Rezoning Plan

3440 Quail Run

PETITION NO: Z-3

PLANNING COMMENTS:

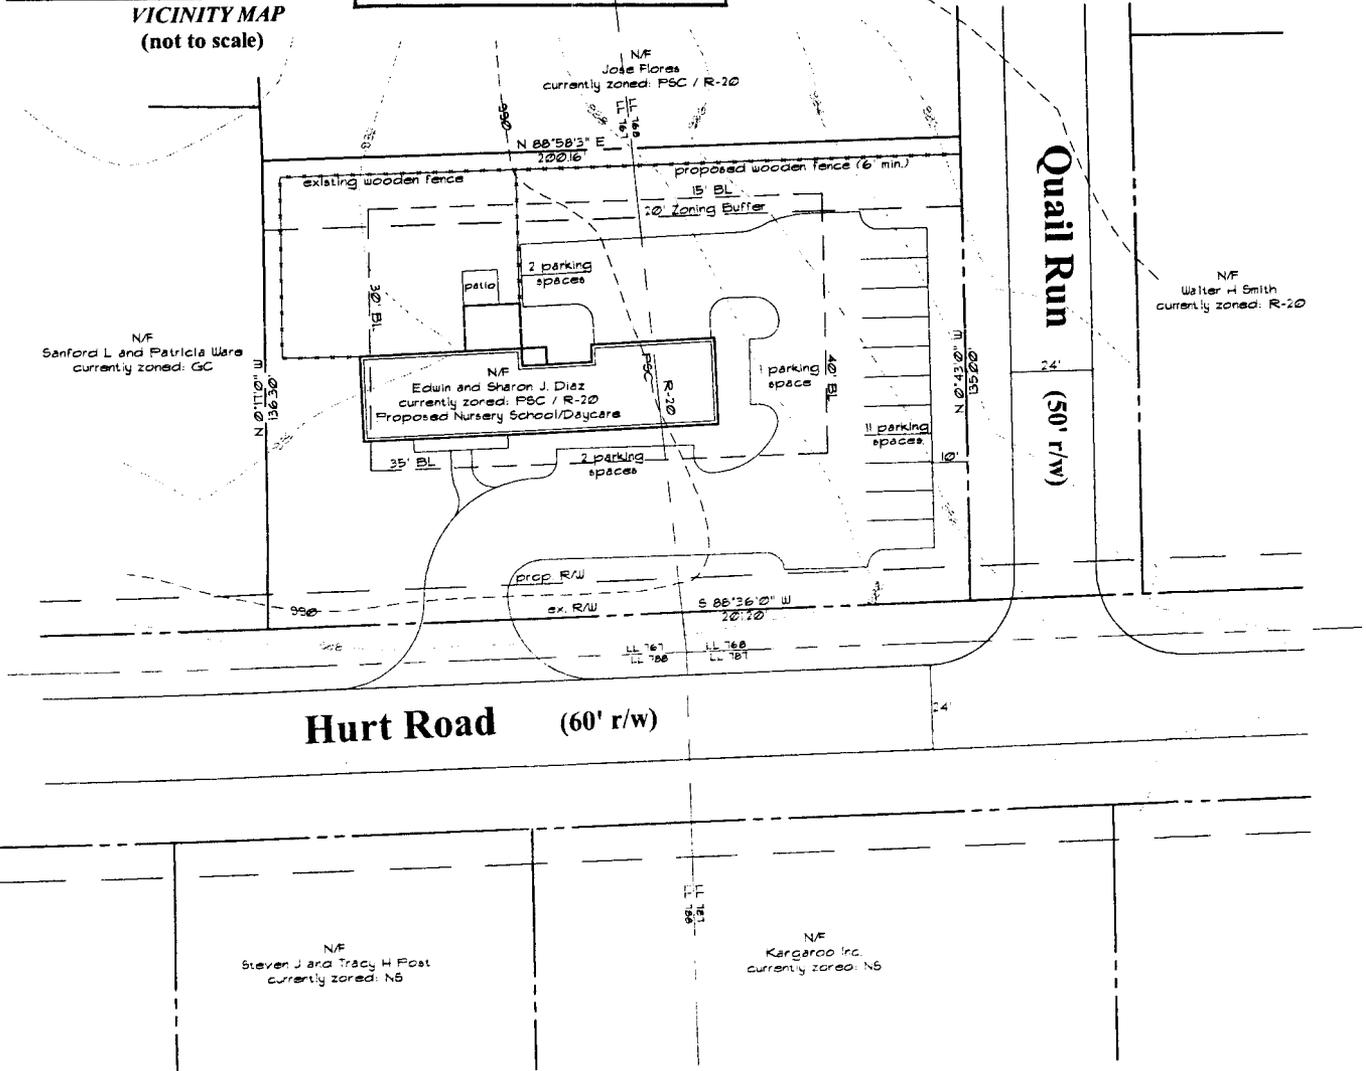
- 1. Reduce the rear setback from 30-feet to 27-feet (existing); and
- 2. Reduce the required number of parking spaces from 20 parking spaces to 16 parking spaces.

- Provide comprehensive hydrology/stormwater controls to include development of out parcels.
- Submit all proposed site improvements to Plan Review.
- Any **spring activity** uncovered must be addressed by a qualified geotechnical engineer (PE).
- Structural fill _____ must be placed under the direction of a qualified registered Georgia geotechnical engineer (PE).
- Existing facility.
- Project must comply with the Water Quality requirements of the CWA-NPDES-NPS Permit and County Water Quality Ordinance.
- Water Quality/Quantity contributions of the existing lake/pond on site must be continued as baseline conditions into proposed project.
- Calculate and provide % impervious of project site.
- Revisit design; reduce pavement area to reduce runoff and pollution.

- No Stormwater controls shown _____
- Copy of survey is not current - Additional comments may be forthcoming when current site conditions are exposed.
- No site improvements showing on exhibit.

1. This parcel is located in an older subdivision with limited stormdrainage system capacity. The proposed site plan more than doubles the impervious area of this site. A stormwater management facility will be required and although this is noted on the site plan no location is shown. Since there is no available existing discharge other than gutter flow within the street, the detention discharge must be piped along the Quail Run R/W to the nearest existing structure located at 3416 Quail Run.

Relocate access driveway along Hurt Road and remove driveway along Quail Run.

Install sidewalk, curb and gutter along the road frontages.

As necessitated by this development for egress from Hurt Road a deceleration lane will be required.

Recommend relocating the access driveway to Hurt Road and removing the existing driveway on Quail Run to accommodate commercial traffic.

Recommend building the proposed driveway to comply with Cobb County commercial standards.

Recommend installing sidewalk, curb and gutter along the road frontages.

Recommend a deceleration lane along Hurt Road.
